RESOLUTION NO. 18-02

A RESOLUTION APPROVING THE SITE PLAN FOR W.C. PETTY SCHOOL

REPORT TO: VILLAGE PRESIDENT and BOARD OF TRUSTEES
FROM: MICHAEL S. GARRIGAN, AICP, CNU-A, Community Development Director
DATE: January 2, 2018
SUBJECT: REPORT TO VILLAGE PRESIDENT

CASE: W.C. Petty School
17-18 SU/SPR

**OVERALL EXTERIOR
ELEVATIONS**

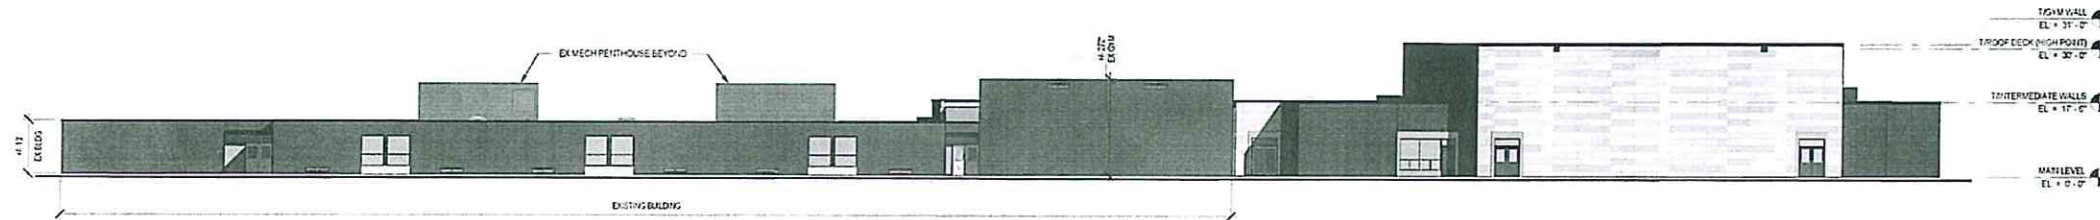
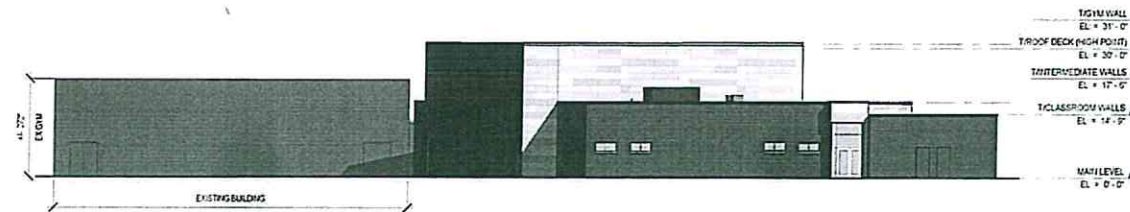
The Village’s Site Plan Review Ordinance requires that civic buildings be constructed out of a predominance of quality materials including face brick, stone, or glass. The applicant is proposing to

construct a building with a predominance of “Kings Brick” and fiber cement panels. The gymnasium’s façade would be specifically constructed with fiber cement panels and all four elevations incorporate a series of large windows bordered by aluminum frames.

The design of the addition incorporates a contemporary design and the new addition design will be integrated throughout the existing building to incorporate a unified campus design.

Based on the elevations submitted, it appears that all the mechanicals on the roof have been screened with metal parapets surrounding each unit.
